REMARKS TO THE REPLACEMENT DRAWINGS

Amendments to Drawings

EXHIBIT A

Shown herein are all of the figures appearing in the immediate prior version of all (1-60) of the amended replacement drawing sheets.

Fig. 7C

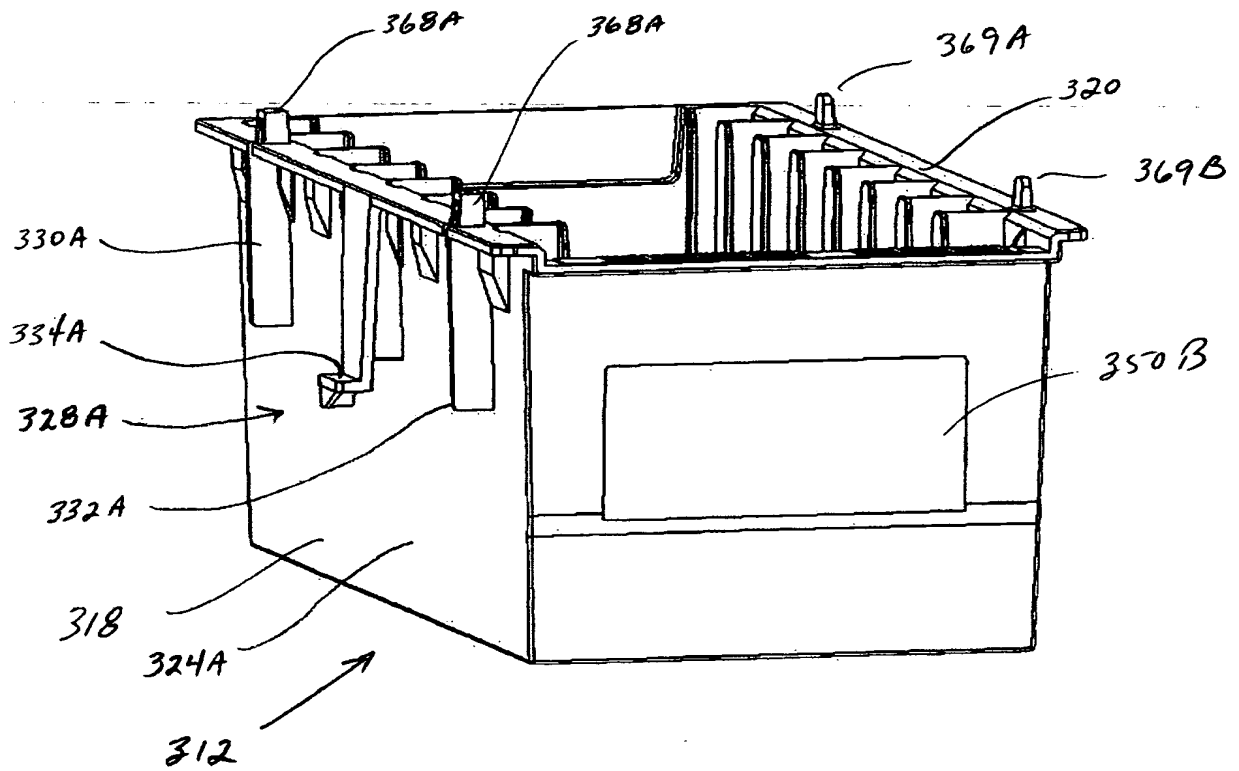
FIG. 7C is amended herein to correct for a miss-label of the second orientation surface associated with side wall 324A from 368A to 368B.

Fig 9c

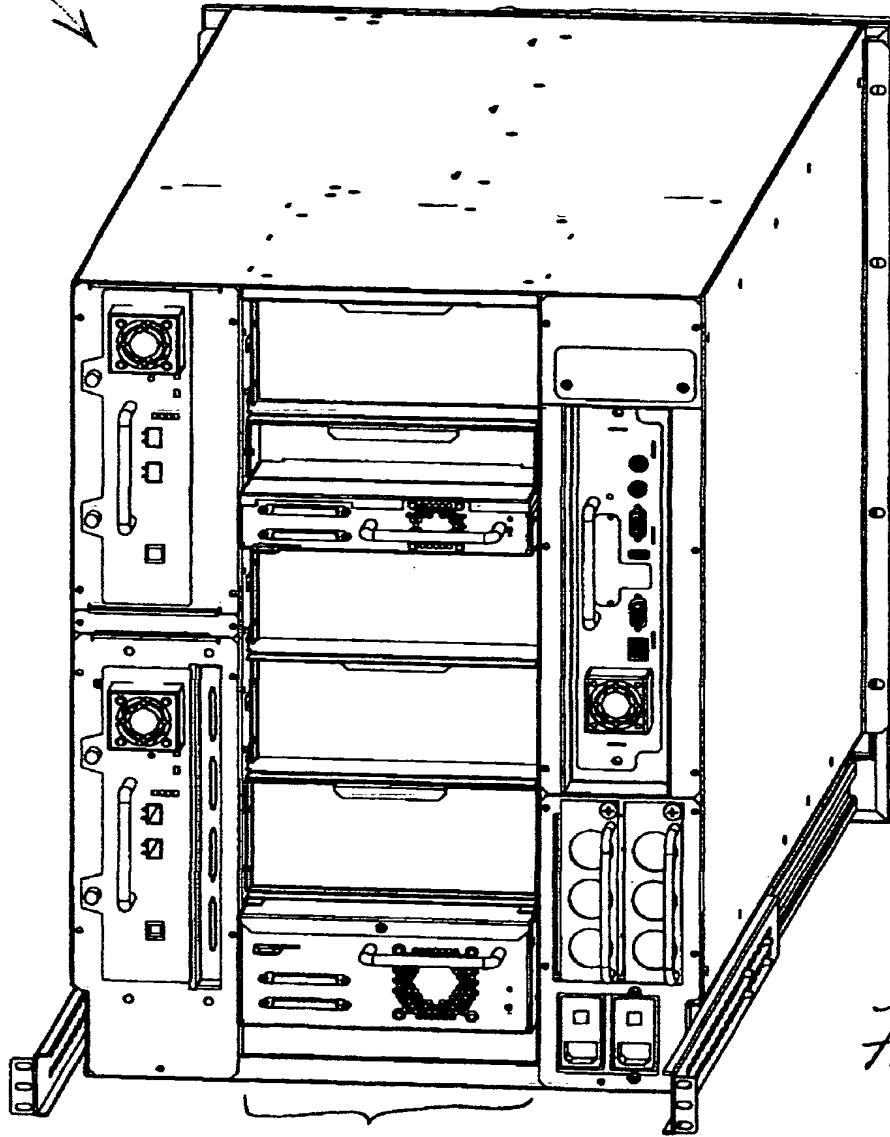
FIG. 9C is amended herein to add labels 450A, 450B, 450C, 450D, 450F for the full-height drive spaces, 456A and 456B for the half height drive spaces, 473 for the half-height drive block-off plate, 471 for the half-height sled, 460 for the full-height drive block-off plates, 470 for the full-height drive sled 470 for housing a full-height LTO tape drive 472.

Fig. 9D

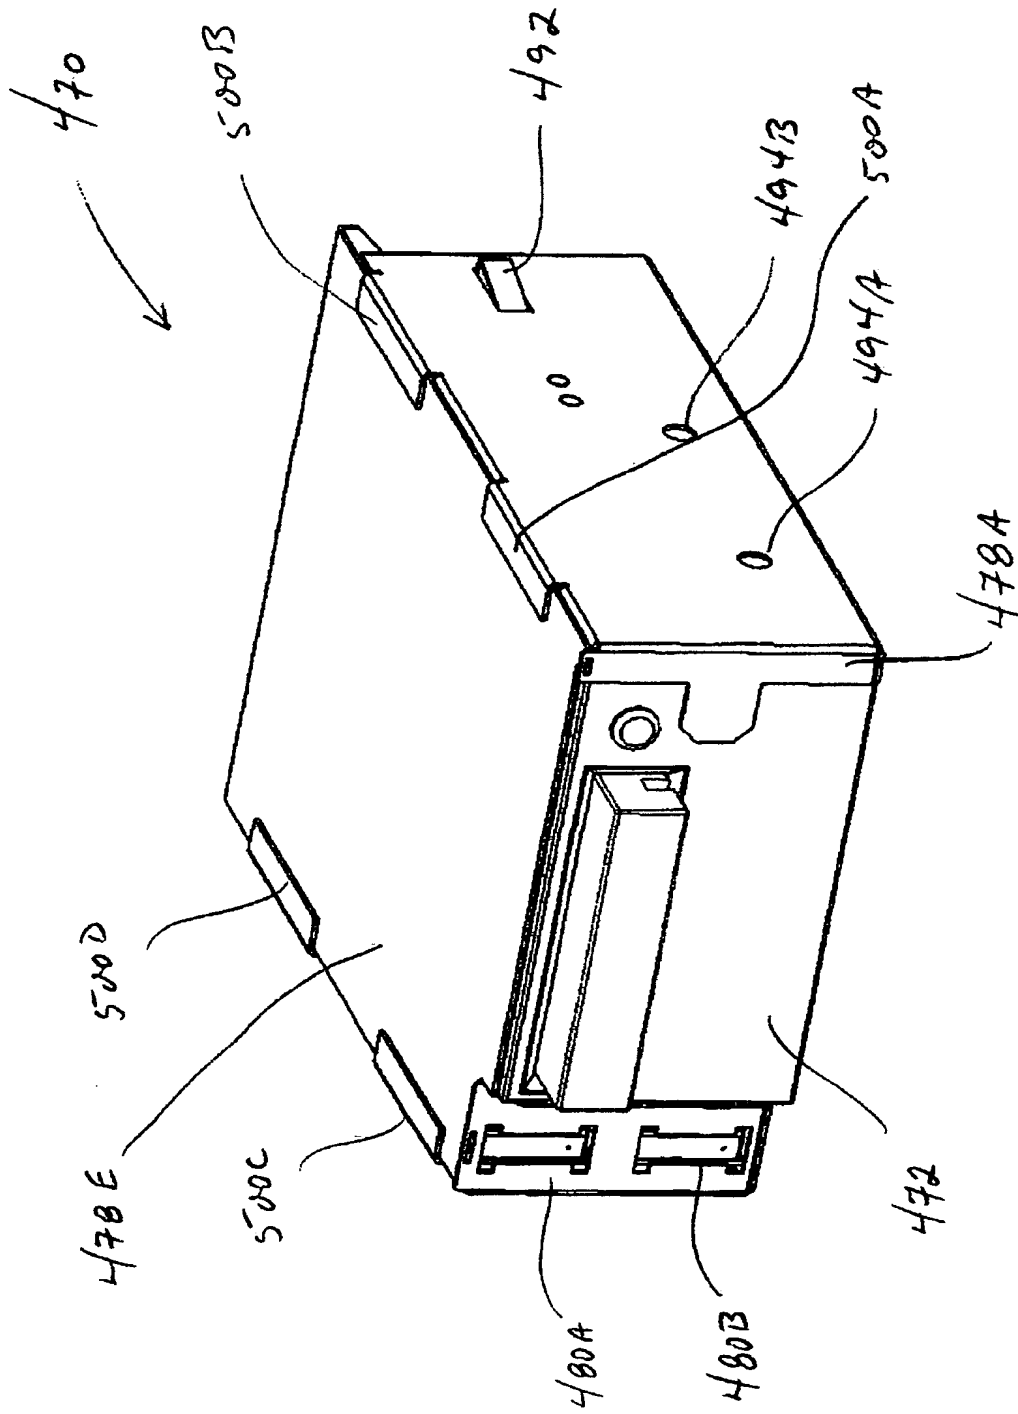
FIG. 9D is amended herein to add labels 478C for the first lateral side associated with the housing of the sled 470, 475 for the receptacle associated with the drive 472, 130 for the LTO tape cassette.

Fig. 15A1

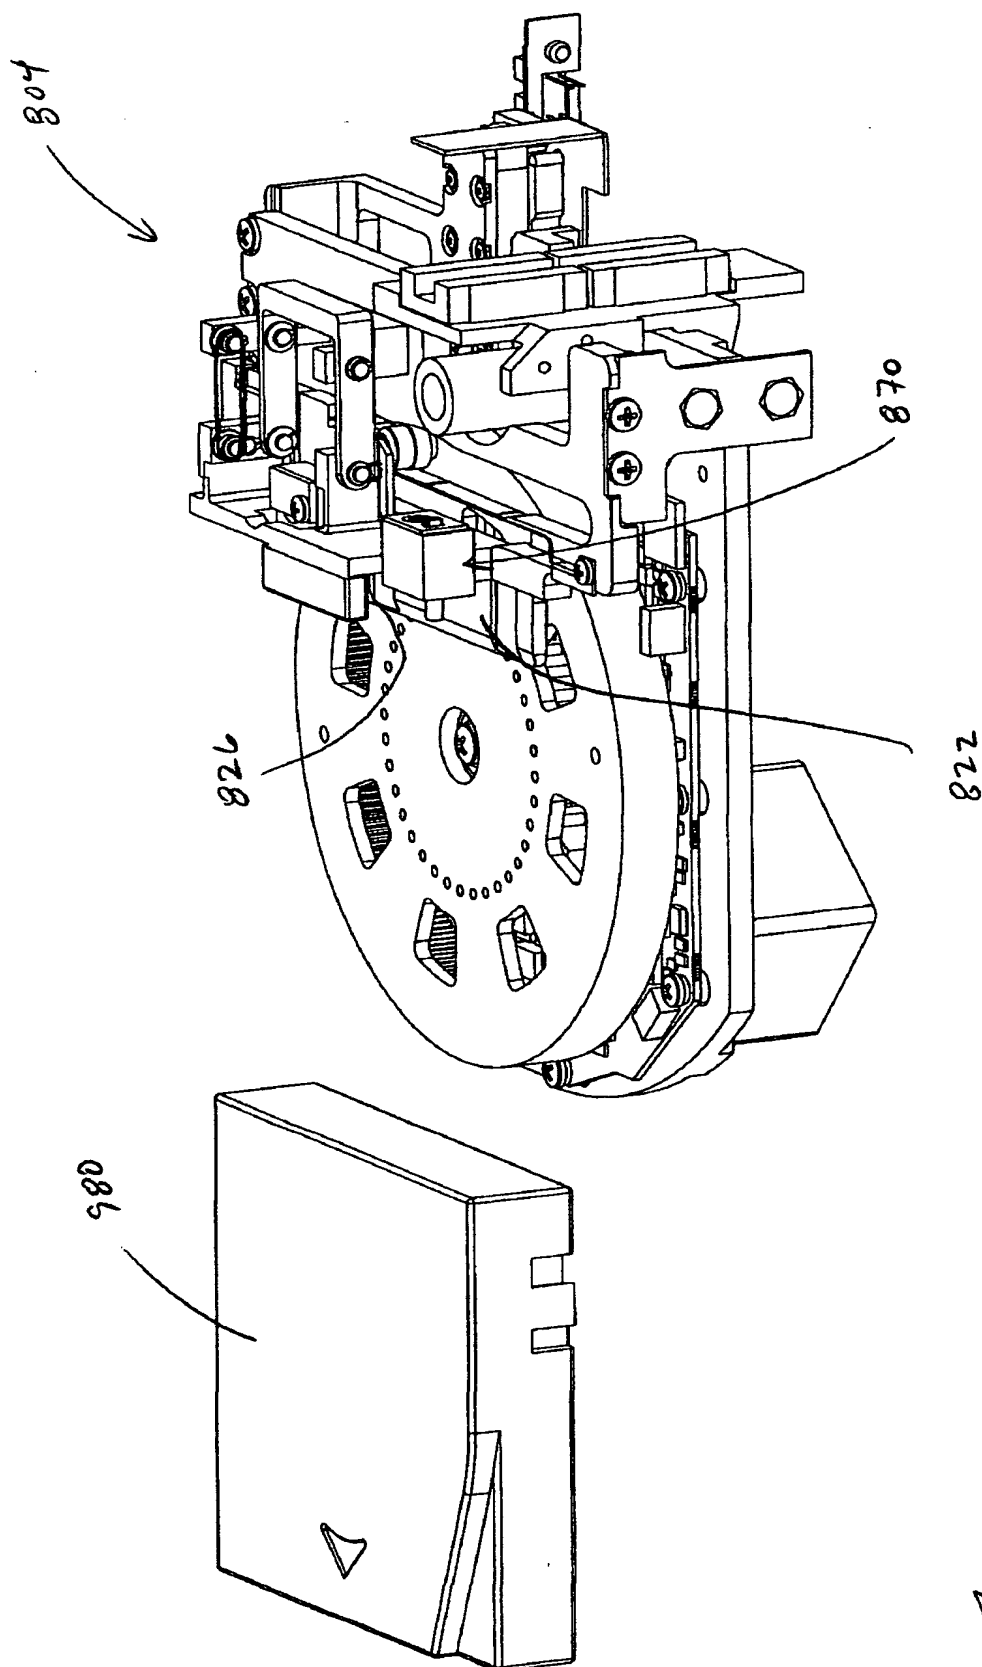
FIG. 15A1 is amended herein to add labels 806 for the crank assembly and replace 980 with 130 for the LTO tape cassette.

Fig. 15A2

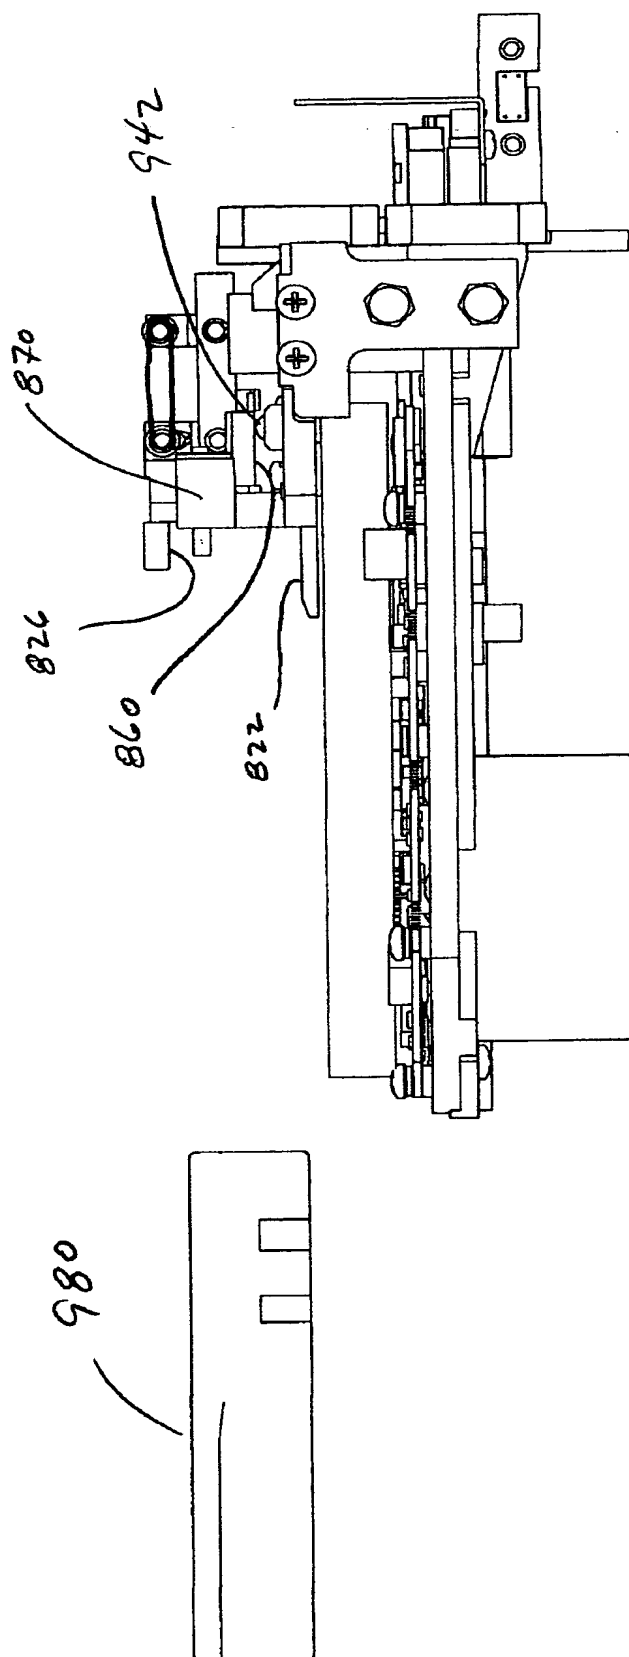
FIG. 15A2 is amended herein to replace 980 with 130 for the LTO tape cassette.

Fig. 15B1

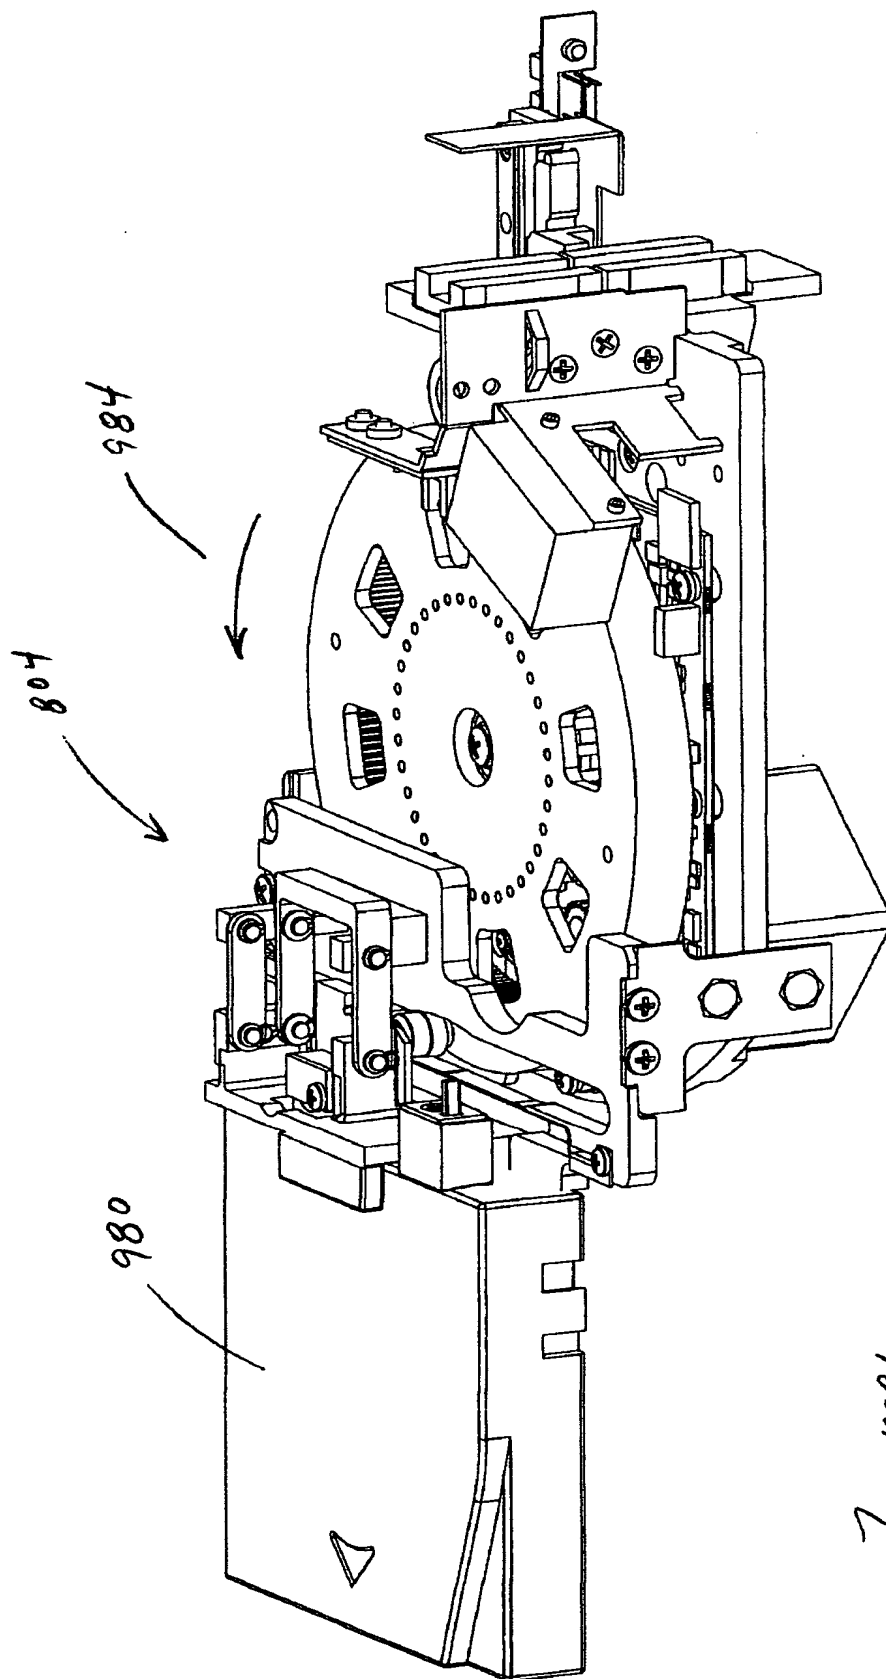
FIG. 15B1 is amended herein to replace 980 with 130 for the LTO tape cassette.

Fig. 15B2

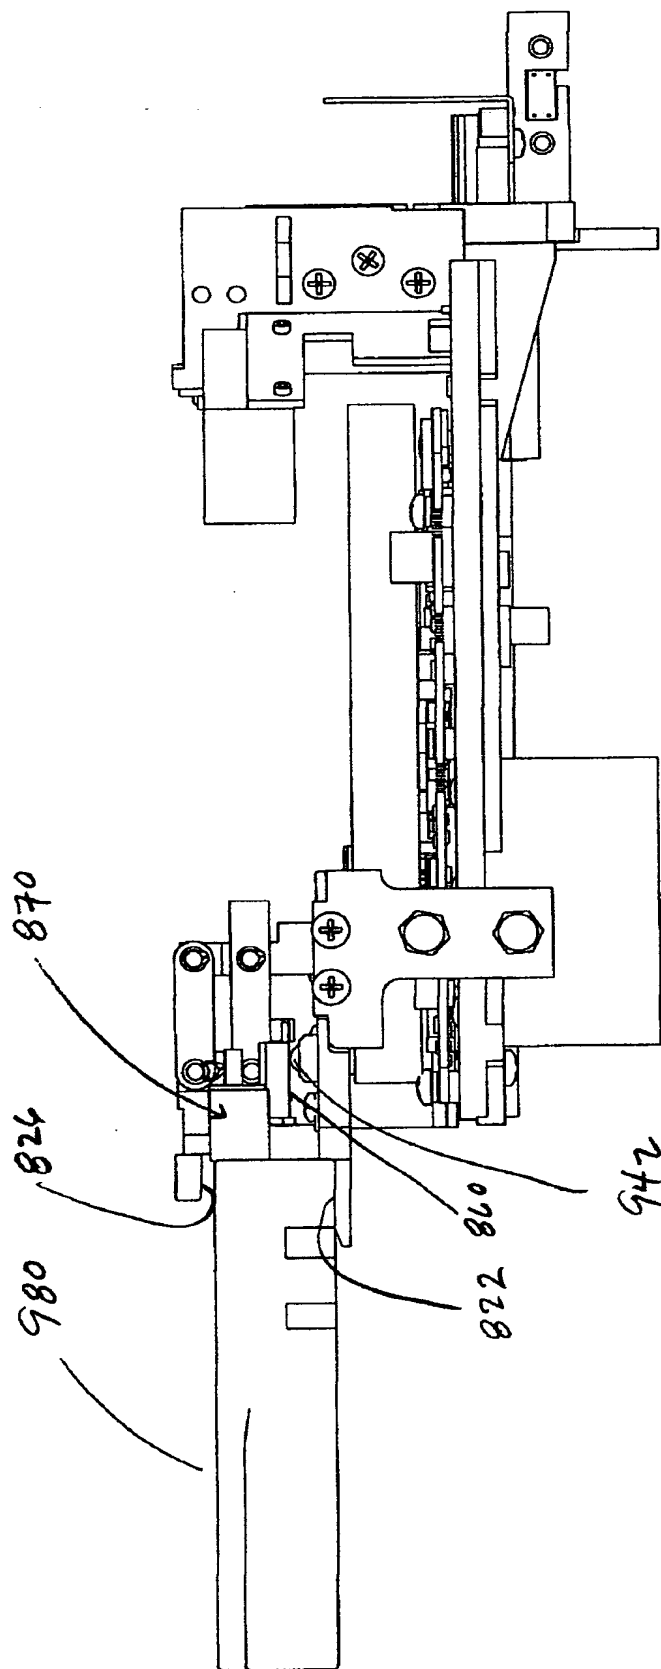
FIG. 15B2 is amended herein to replace 980 with 130 for the LTO tape cassette.

Fig. 15C1

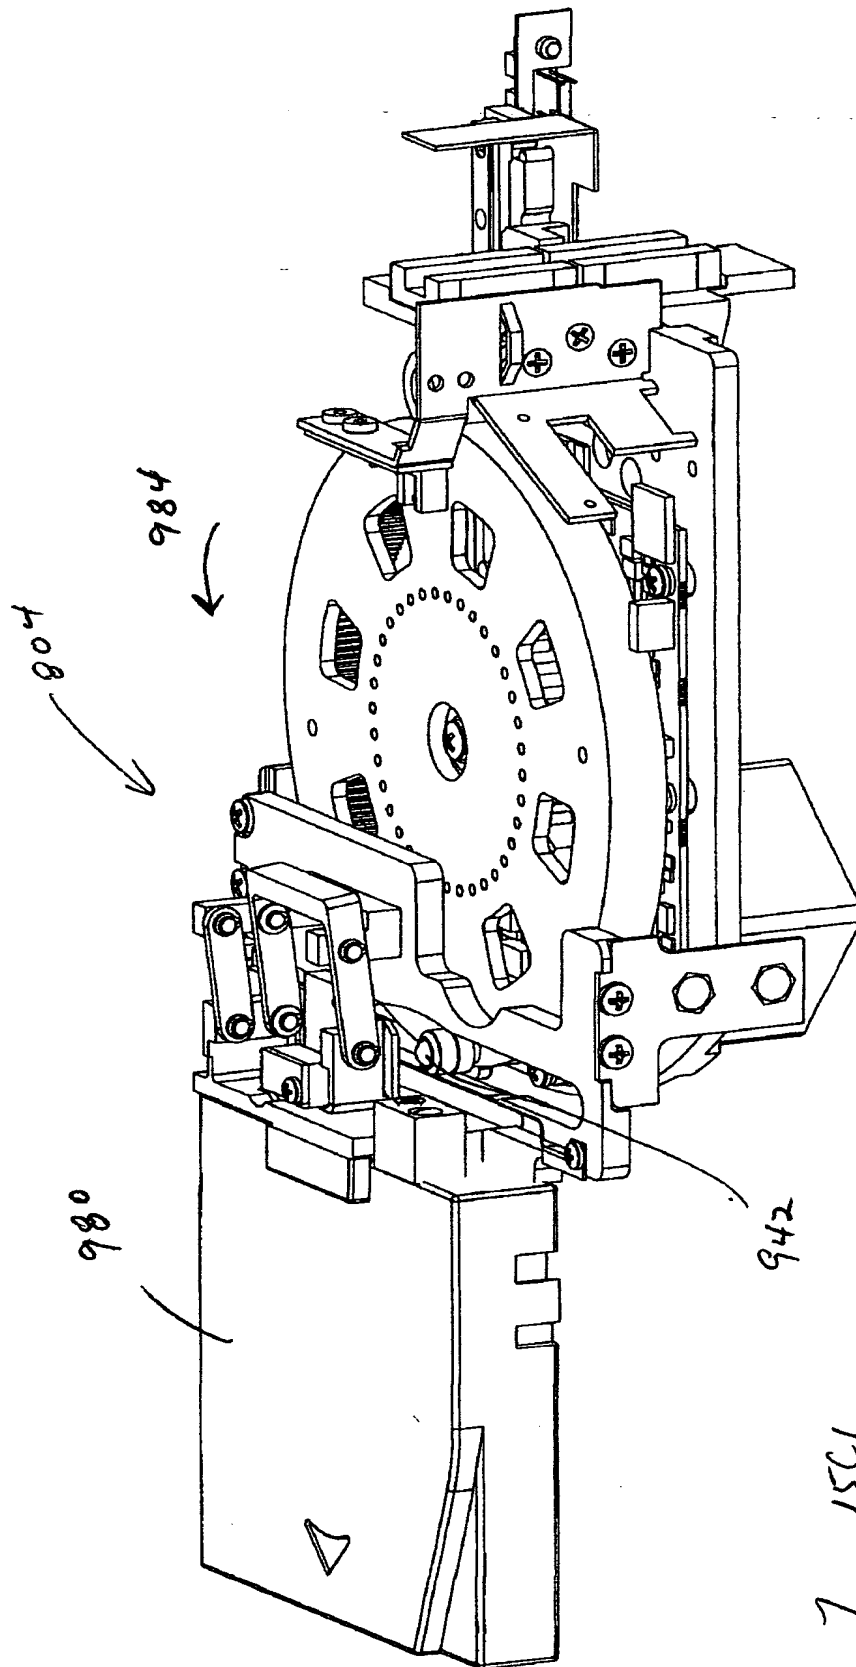
FIG. 15C1 is amended herein to replace 980 with 130 for the LTO tape cassette.
